Maule Aircraft Corporation

Service Letter #18.
Models Effected M4-220C and M-4-220S
Mandatory on Serial NO's 2001c thru 2025c, 2001S

SERVICE LETTER #18

THROTTLE CONTROL

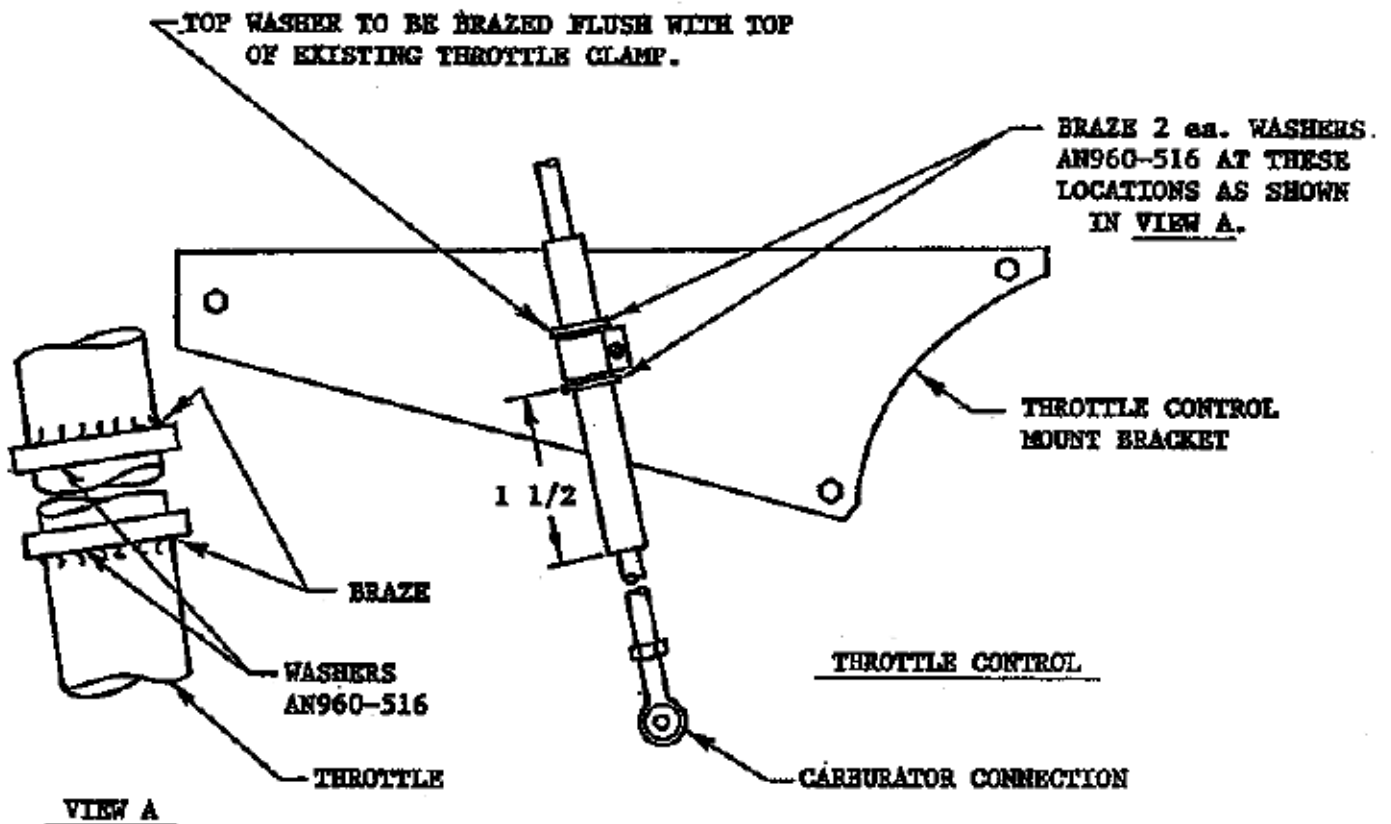
We have discovered a possible malfunction of the throttle linkage attachment.

This Service Letter is to be complied with within the next 30 days. Please fill out enclosed card and return at time of compliance.

CAUTION: DO NOT OVERHEAT WHEN BRAZING WASHERS.

NOTE: LUBE SHAFT WITH LIGHT WEIGHT ENGINE OIL AFTER BRAZING.

BILL OF MATERIAL:

2 ea. AN960-516 WASHERS
